STATE OF VERMONT AGENCY OF TRANSPORTATION

PROPOSED IMPROVEMENT BRIDGE PROJECT TOWN OF RICHFORD COUNTY OF FRANKLIN BRIDGE NO. 41 ON TOWN HIGHWAY NO. 2

RECORD PLANS	
CONTRACTOR	BLOW & COTE - MORRISVILLE, VT
RESIDENT ENGINEER	CARL GLEASON
CONSTRUCTION BEGAN	MARCH 7, 2008
CONSTRUCTION COMPLETE	MAY 5, 2009
RECORD PLANS BY	CARL GLEASON
I HEREBY CERTIFY THAT ALL THE CONSTRUCTION REQUIRED BY THIS SET OF DRAWINGS HAS BEEN ACCOMPLISHED AS INDICATED HEREIN	
BY	<i>Carl Gleason</i> RESIDENT ENGINEER
DATE	6/14/10
NOTE: Any further information concerning final quantities, amounts or other details relative to this project may be found at Central Files in the electronic archives

DIRECTOR OF PROGRAM DEVELOPMENT	
APPROVED <i>Warren Tripp</i>	DATE 12/16/11
PROJECT MANAGER: WARREN TRIPP	
PROJECT NAME: RICHFORD	
PROJECT NUMBER: BHF 0302 (3) S	
SHEET 1 OF 41 SHEETS

PLAN

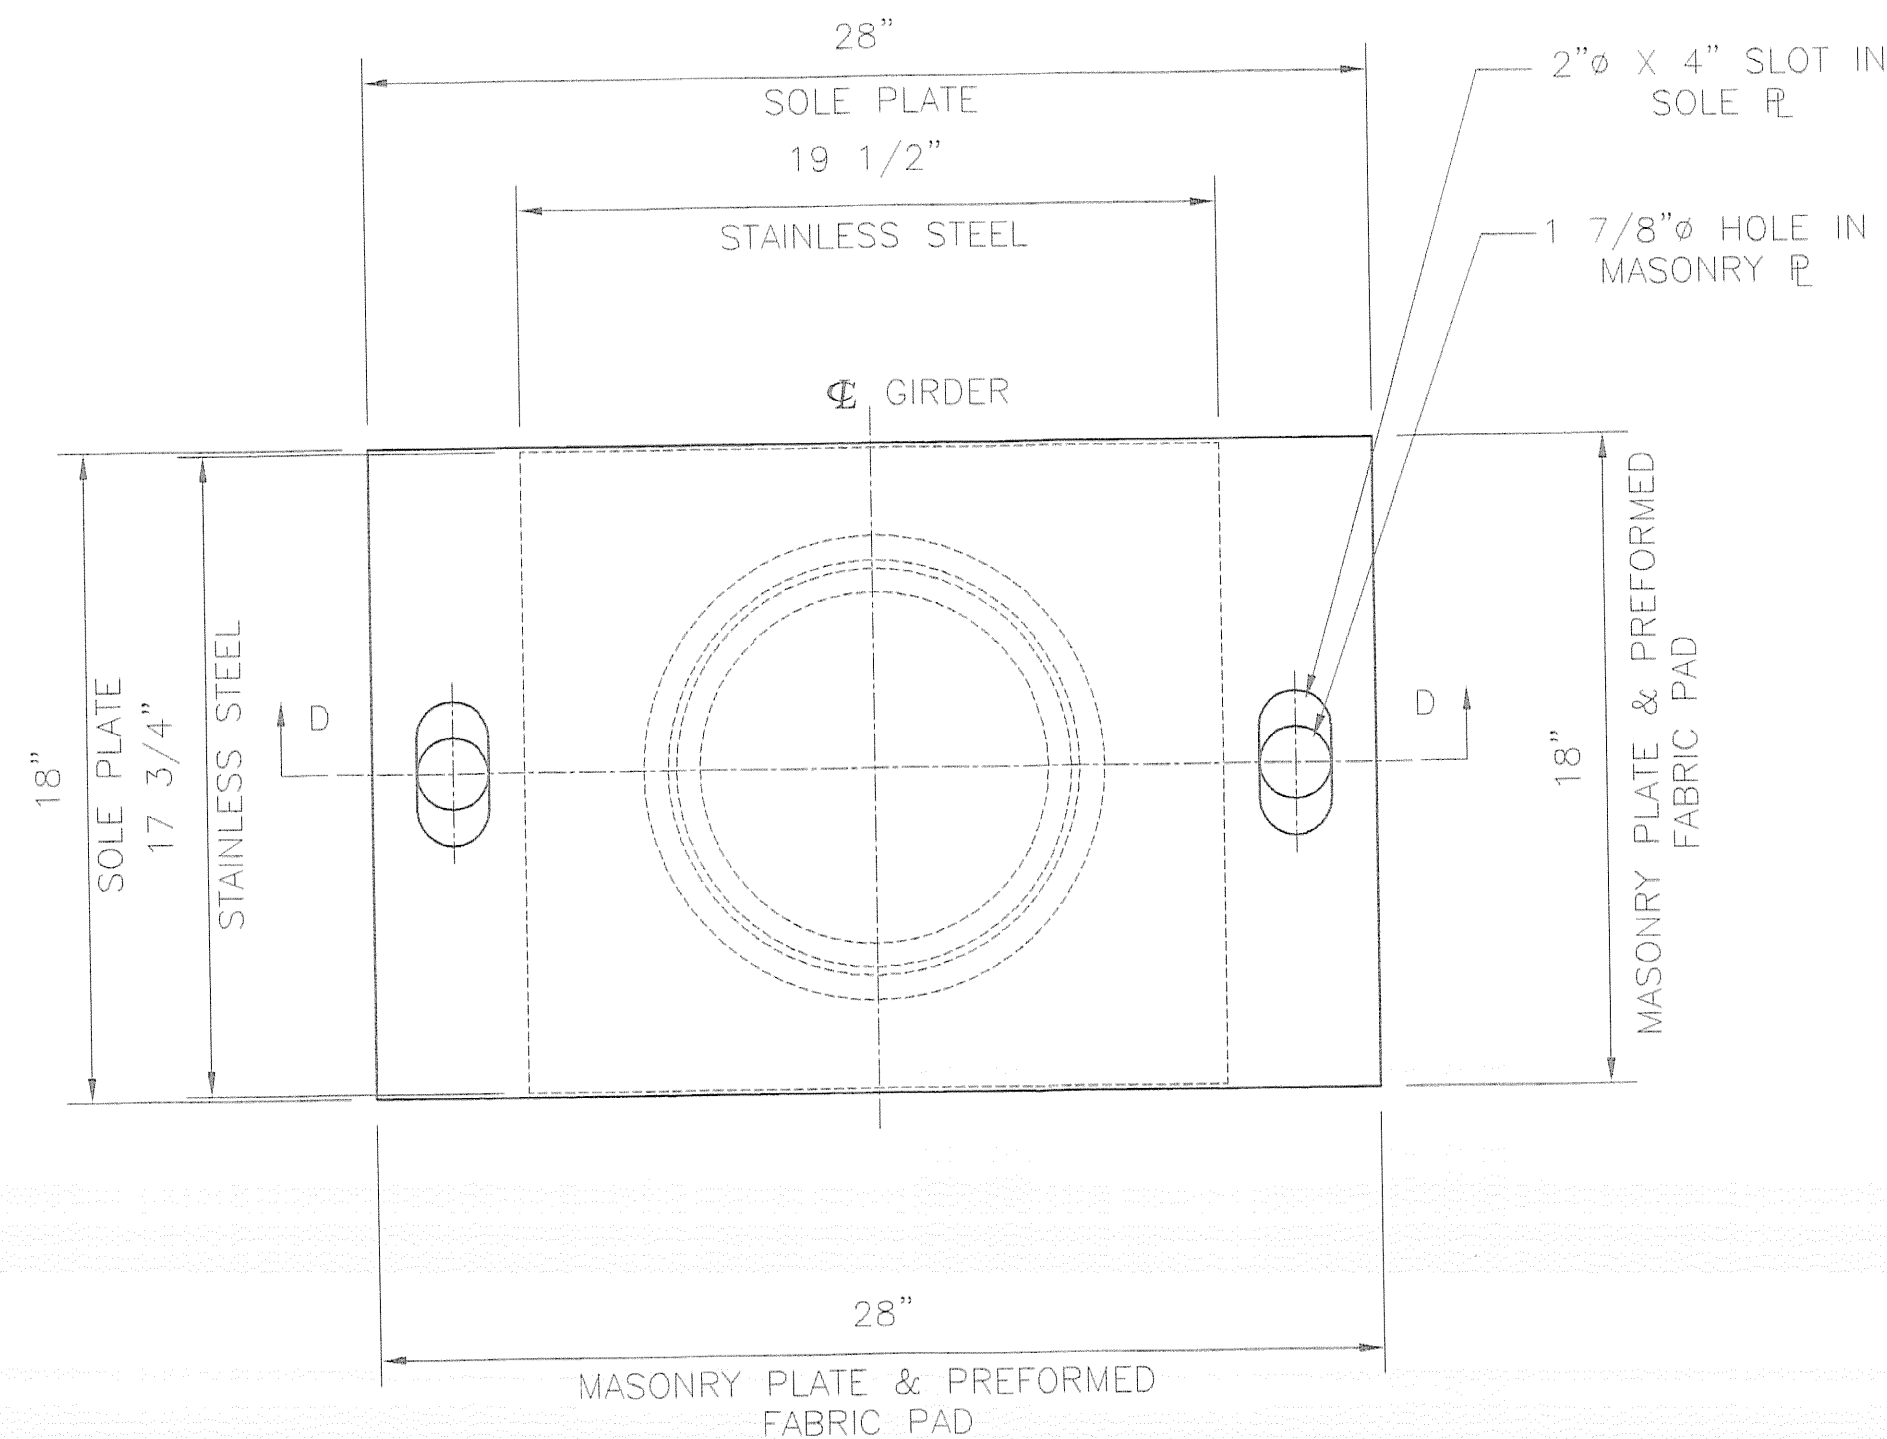
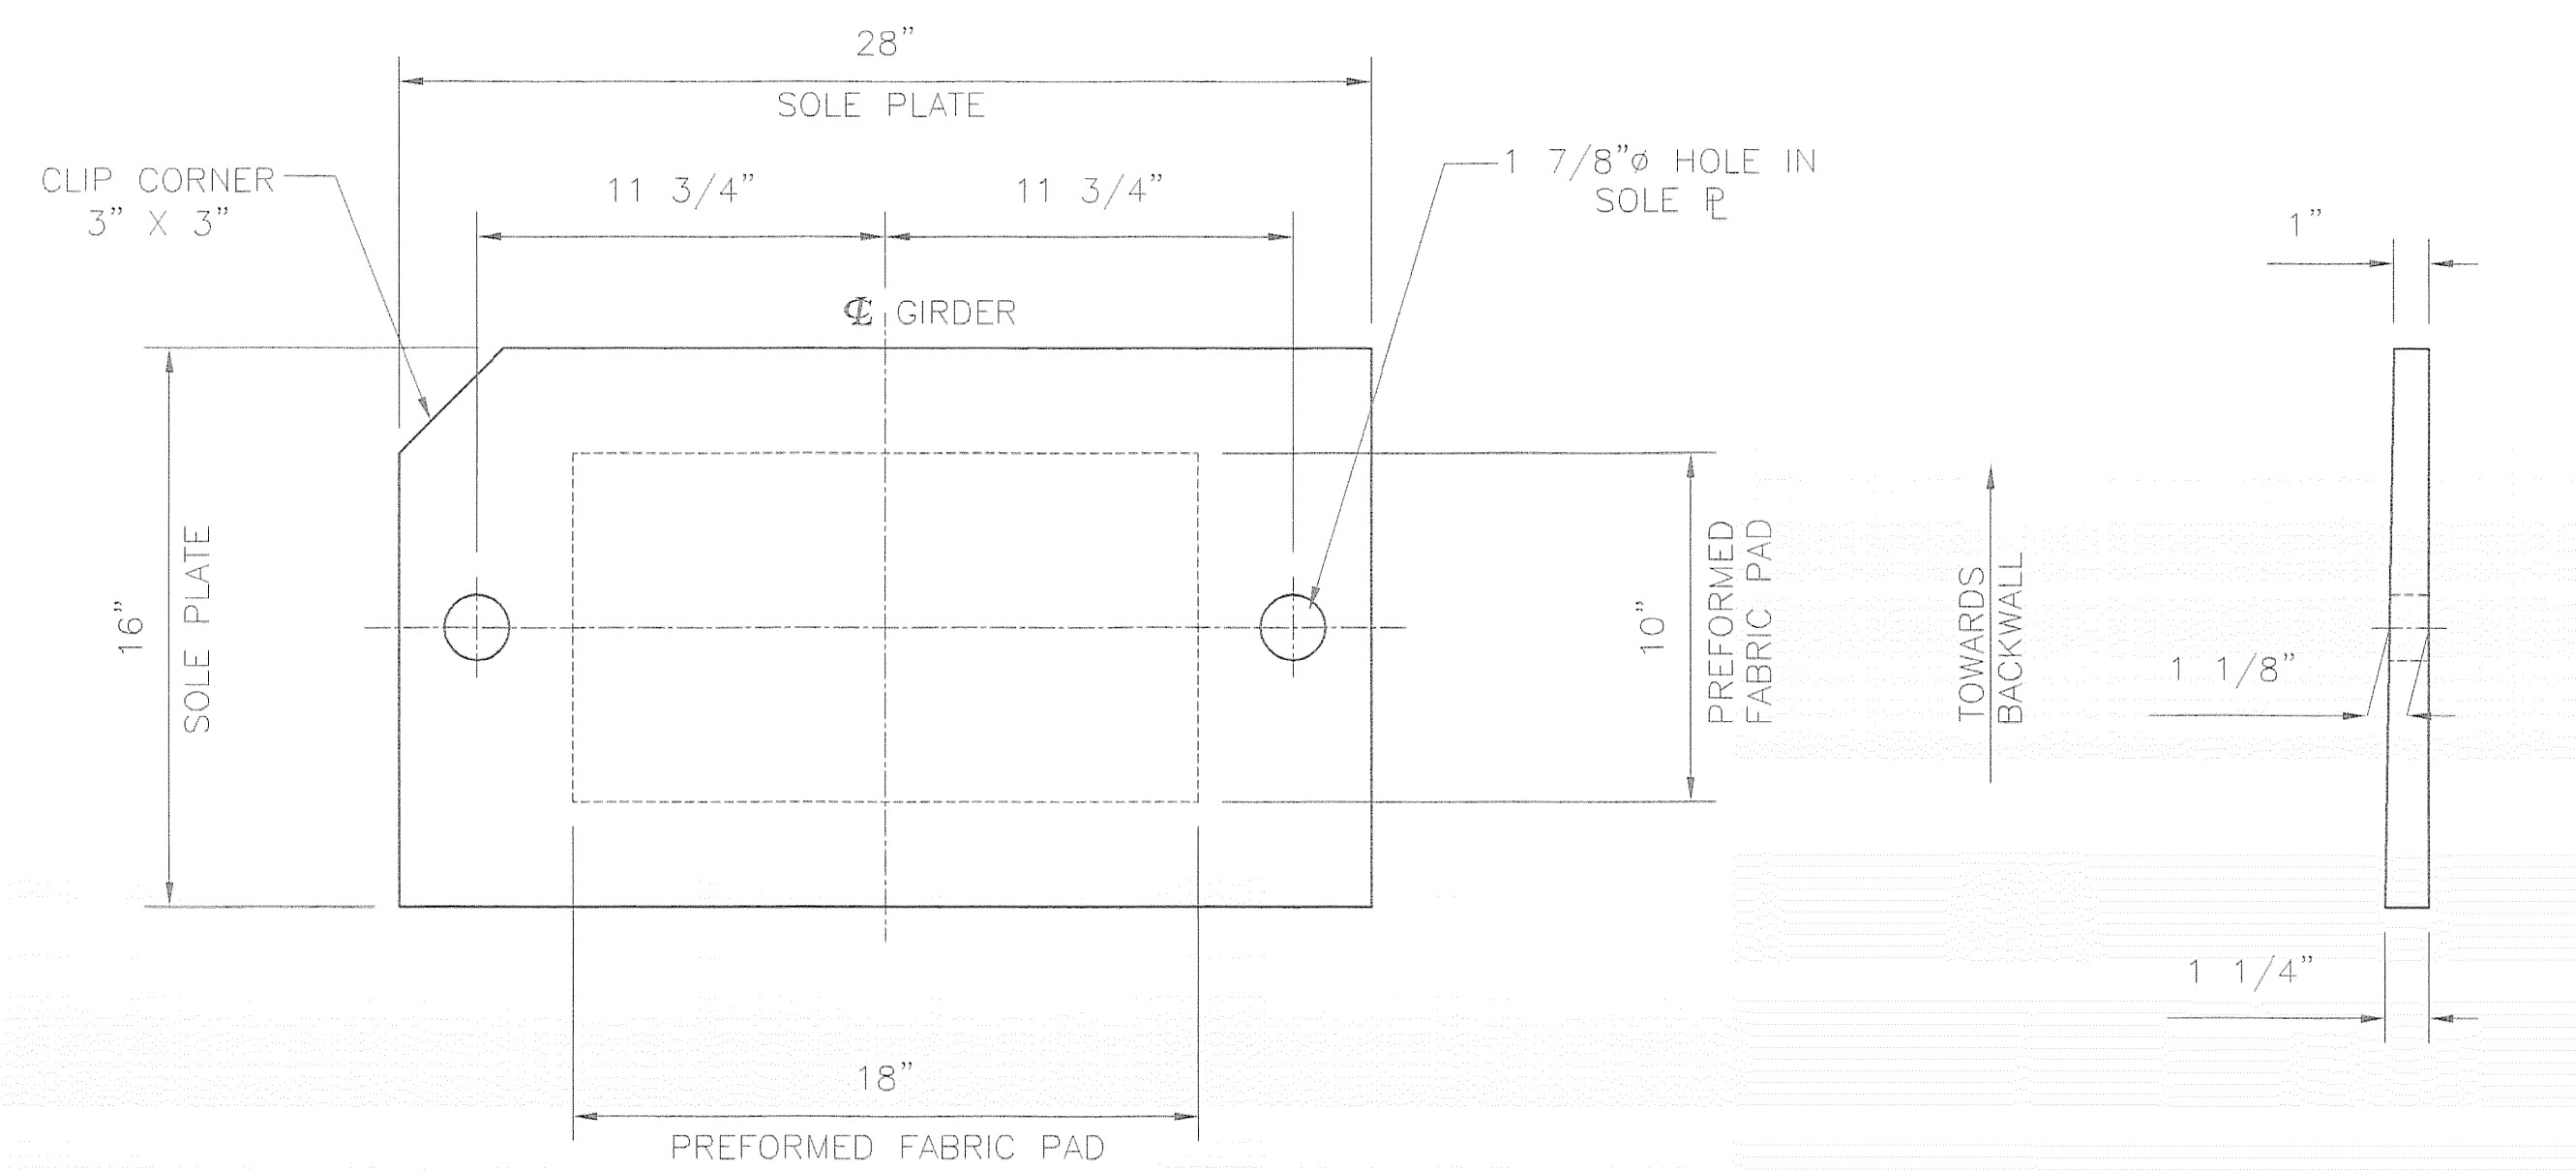
Plan Sheets Number 5057, 5058, and 5059, Welding Procedures FCAW-FILLET, GTAW-WF, and Bonding Procedure EMS-QC-110 **are approved**. If any changes are made to any of these sheets, please submit white prints for our use in record plans for this project. Otherwise, our file copy will become the record set.
